U.S. Department
of Transportation
**Federal Aviation
Administration**

Subject: Global Alternative Method of Compliance (AMOC) request for Airworthiness Directive (AD) 2012-10-11, Docket No. FAA-2012-0324; Directorate Identifier 2012-CE-008-AD for the Burkhart GROB Luft- und Raumfahrt GmbH Model G 109 and G 109B Powered Sailplanes.

Global AMOC - Alternative Inspection Method

AD 2012-10-11, Paragraphs (f)(1)(ii) and (f)(1)(iii)

Picture 1 – G 109 110 mm Opening Location

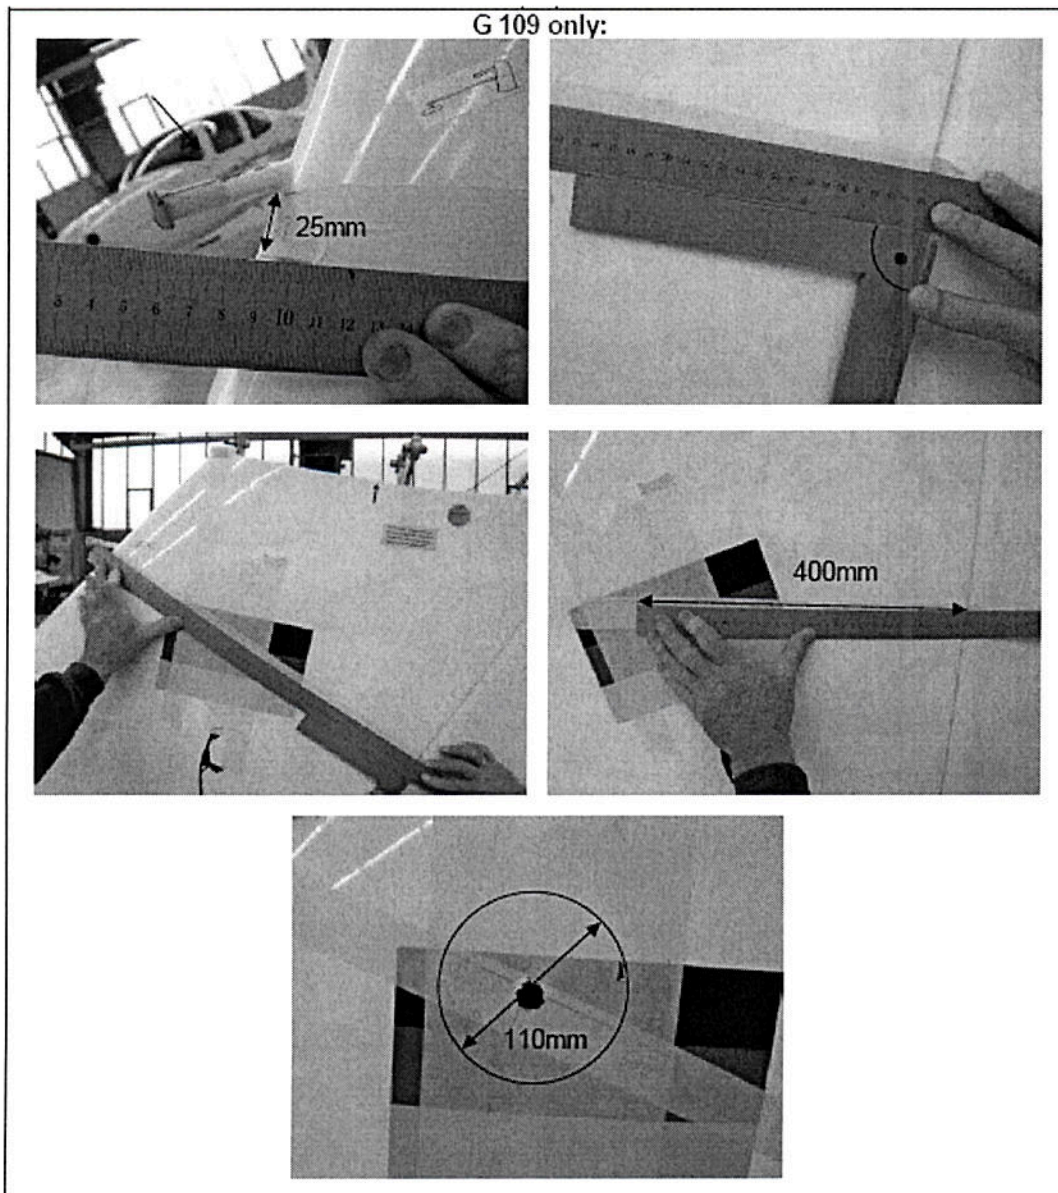
1. Make a 16 mm diameter hole anywhere within the boundary of the 110 mm inspection opening defined in Grob Aircraft Repair Instruction Doc. No. RI 817-010/1, issue date December 20, 2011, as specified in Grob Aircraft Service Bulletin MSB817-60, dated November 24, 2011. Picture 1 shows the layout of the 110 mm opening on the model G 109. Picture 2 shows the layout of the 110 mm opening on the model G 109 B. Picture 3 shows a typical example of the 16 mm hole placement.

2. To strengthen and seal this 16 mm hole, remove the foam layer between the inner and outer layers of fiber glass to a radial depth of a minimum of 6 mm and fill this emerging gap with cotton flock resin. With the exception of the smaller dimension of foam removal (6 mm vs. 15 mm), this step is similar to step 7.2 of Grob Aircraft Repair Instruction Doc. No. RI 817-010/1, issue date December 20, 2011, as specified in Grob Aircraft Service Bulletin MSB817-60, dated November 24, 2011.
